NORTHEAST UTILITIES

October 18, 1984

Docket No. 50-423
B11345

Millstone Nuclear Power Station, Unit No. 3
Transmittal of Responses to Safety
Evaluation Report (SER) Confirmatory Items

FIGURE Q 241.3-1

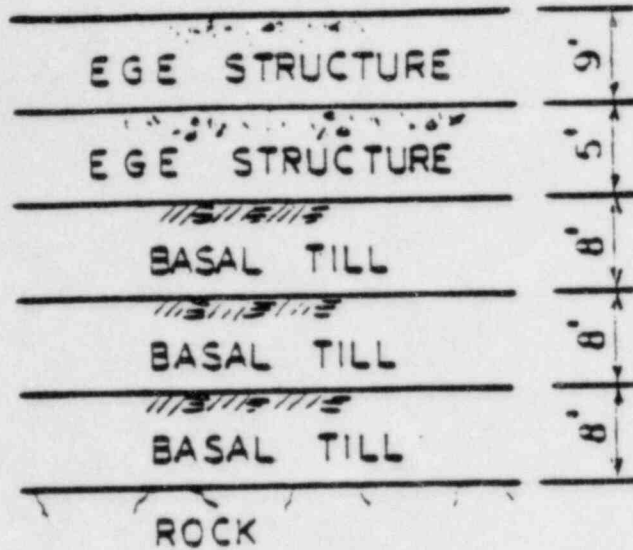
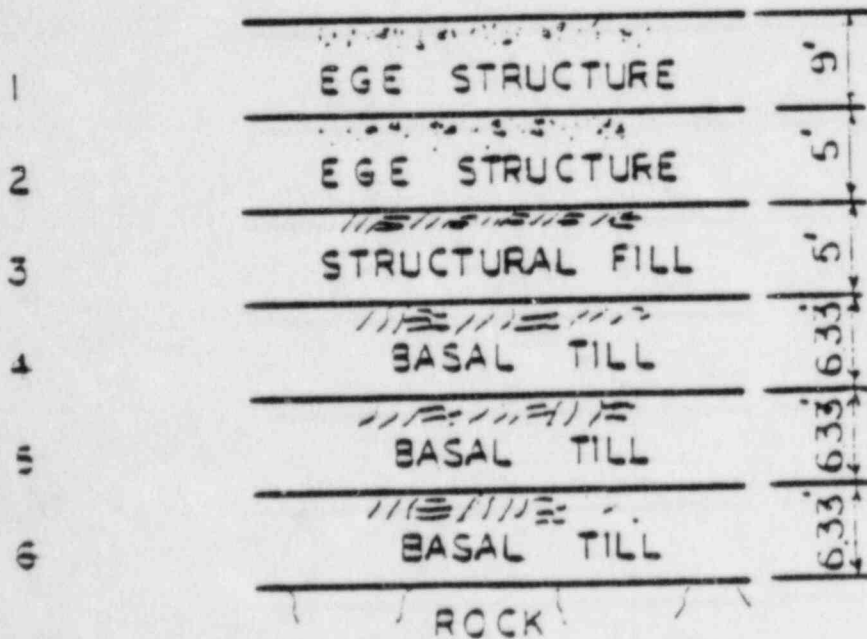
- B. At the request of the NRC Staff the center footing of the EGE will be assumed to be founded on structural fill to elevation 3.5 ft. As a sensitivity study, the effect of this assumption will be examined to verify that the calculated soil amplification will not be affected.

The Emergency Generator Enclosure (EGE) was designed on the basis that the structure footings are founded on 24 ft of dense basal till overlying bedrock. Concerns raised by the NRC (Reference Q241.3) resulted in additional studies on the effects of up to 5 ft of compacted structural fill underlying the footings. This condition does not represent the as-built conditions under the structure, but a comparative analysis was performed and is described below. As-built conditions have a limited depth, averaging less than 5 ft of compacted structural fill used to support footings of the EGE, where they occur adjacent to other structures, and in other local areas where the till was disturbed by construction activity.

The response of the EGE was calculated using the computer program SHAKE, modeling the structure as an equivalent soil, for the case with 24 ft of basal till, and for 19 ft of basal till overlain by 5 ft of structural fill. The comparison showed that the maximum response of the EGE is more limiting when founded on basal till. This sensitivity study shows the EGE was conservatively designed and therefore, Northeast Utilities considers this confirmatory issue as identified in Section 2.5.4.3.2 of the Millstone Unit No. 3 Safety Evaluation Report to be resolved.

Figure Q241.3-1 shows the models used in the 'SHAKE' analyses.
